MIL-M-28787/268A
AMENDMENT 1
31 March 1993

MODULES, STANDARD ELECTRONIC

MULTIPLIER, DIGITAL, KEY CODE AGA

This amendment forms a part of Military Specification MIL-M-28787/268A(EC), dated 20 October 1983, and is approved for use by all Departments and Agencies of the Department of Defense.

FIGURE 16. Power supply filter capacitance test circuit for table XVII.

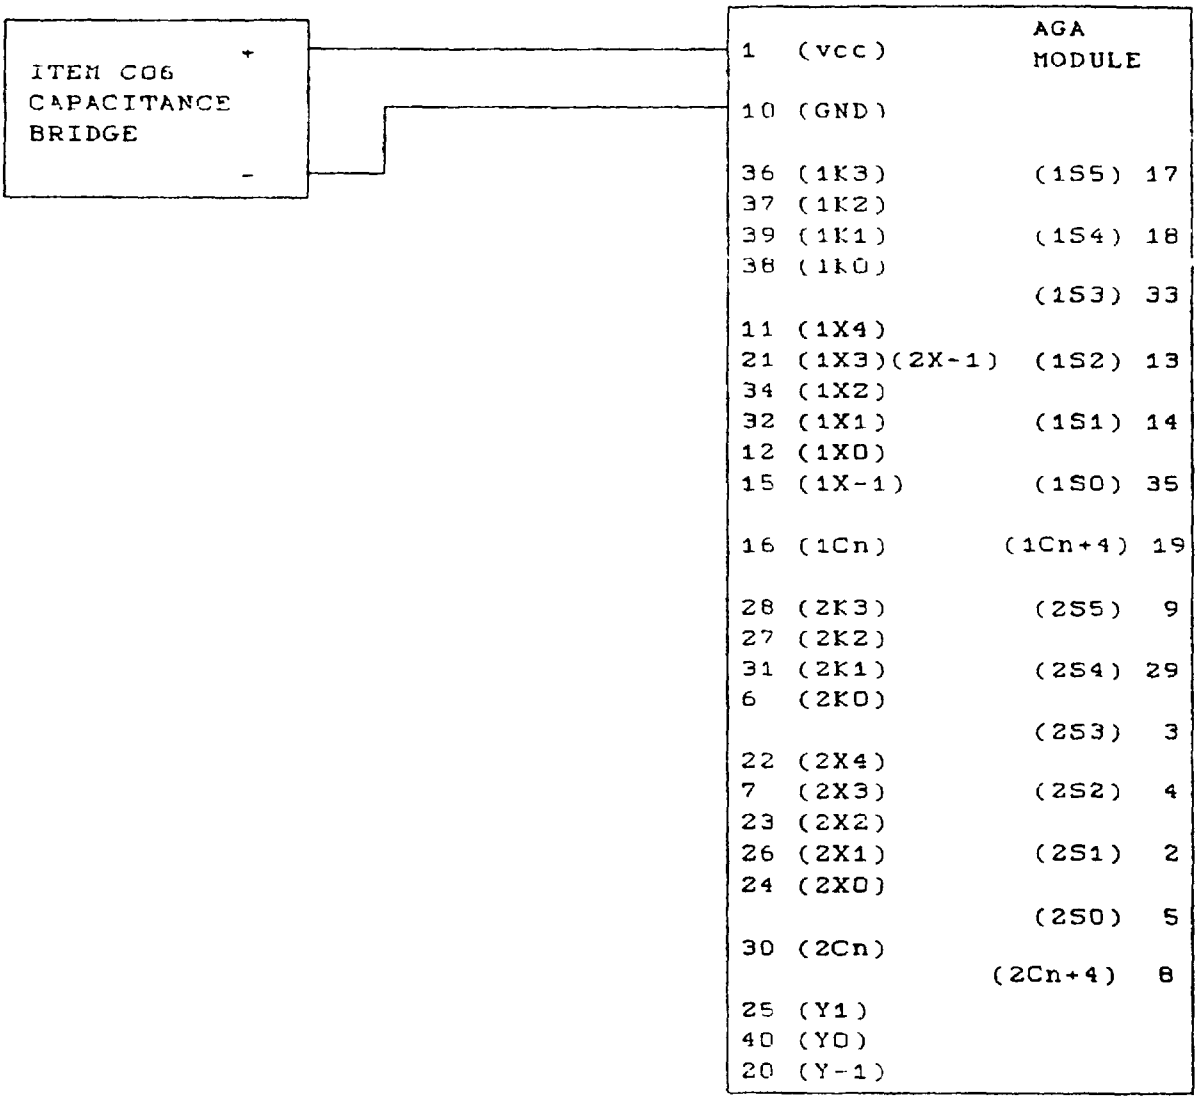
FIGURE 16: Delete and substitute new figure 16 as printed on page 3 of this amendment.

NOTE: Item C06 setup: Frequency = 1kHz.
V_{pk} = 0.3 V maximum.
